CONVAIR

COMMERCIAL CHANGE PROPOSAL

CUSTOMER: Delta Air Lines Inc.

MODEL: 22-2 (Convair "880")

FIGURE 3.19-2

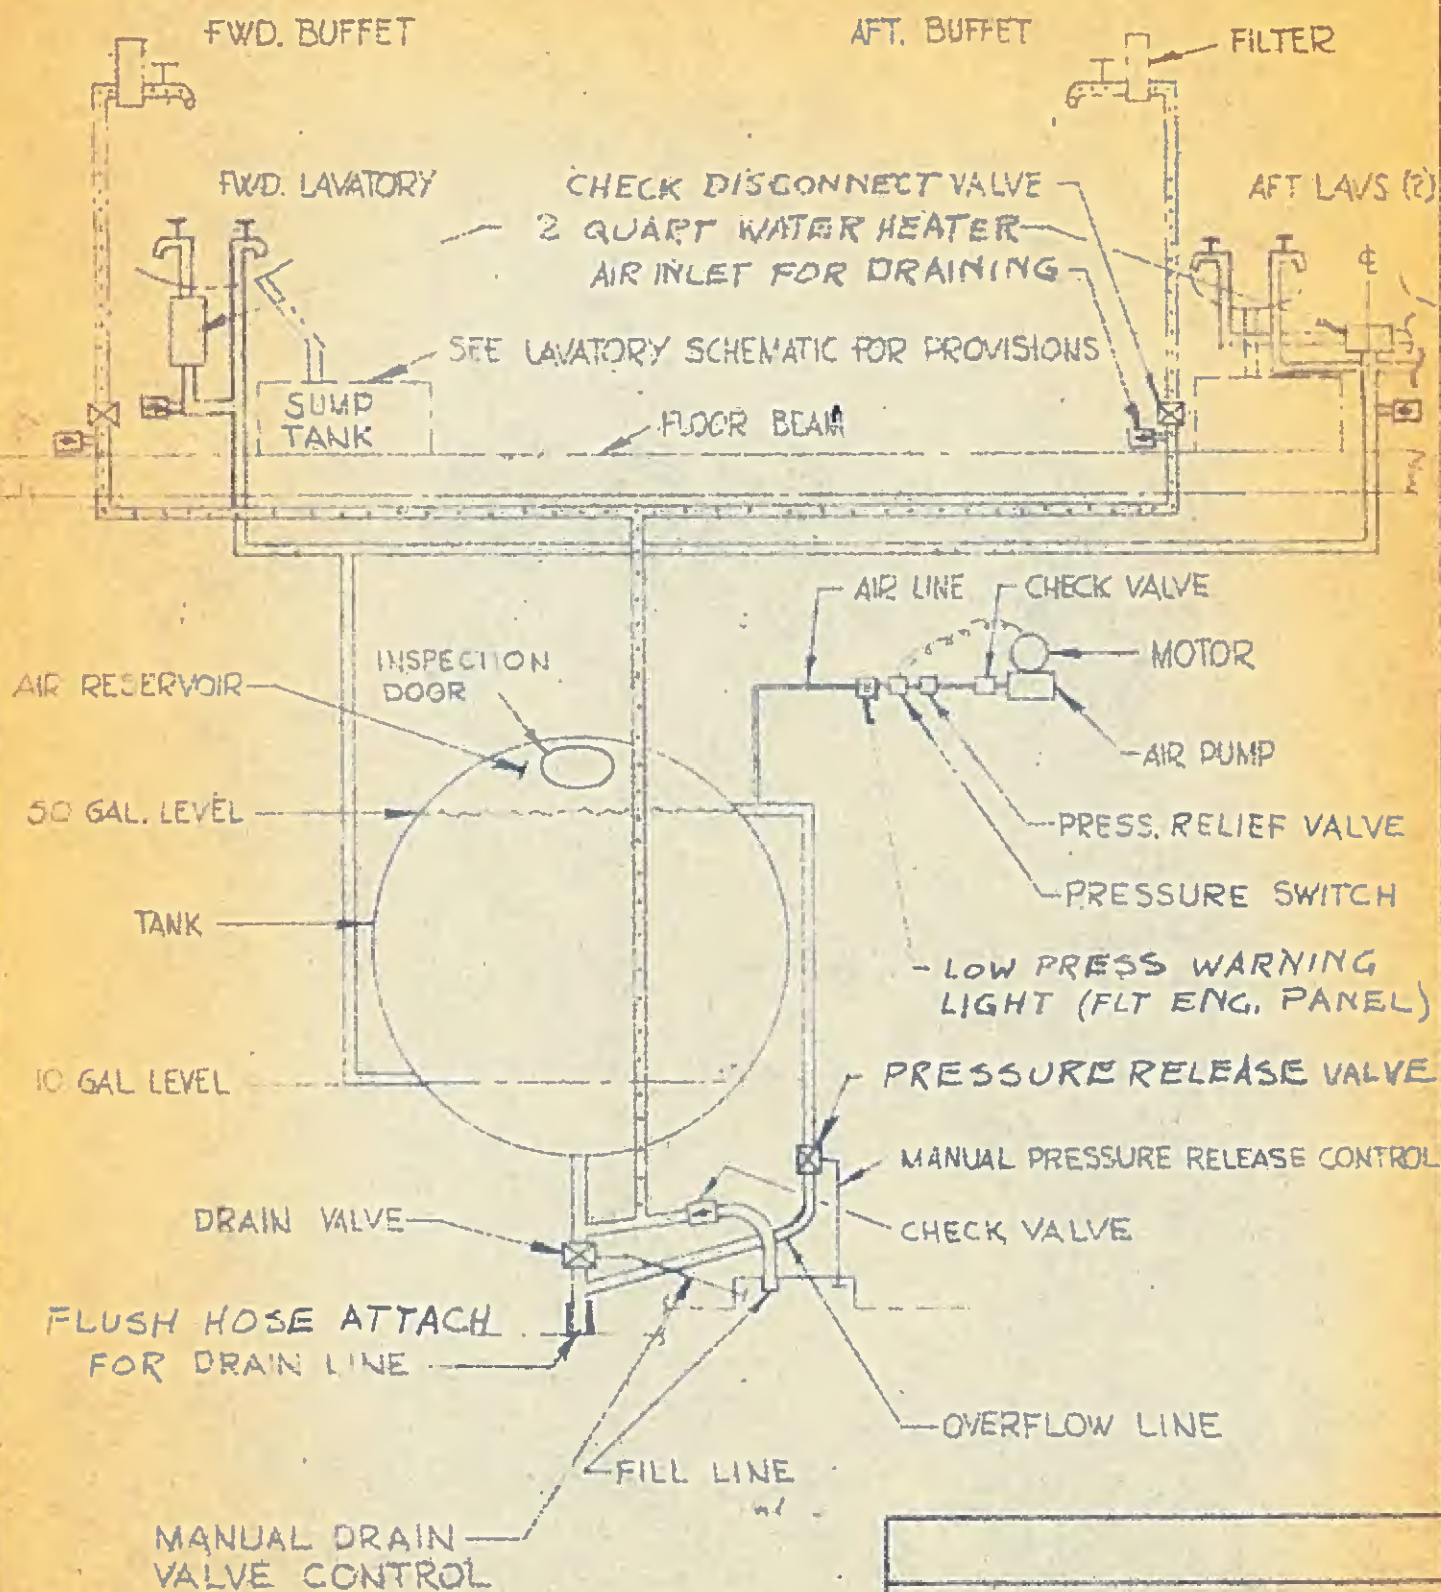
Page 115, FIGURE 3.19-2 WATER SYSTEM:

Enclosure: (A) One copy Figure 3.19-2 WATER SYSTEM SCHEMATIC (for information only)
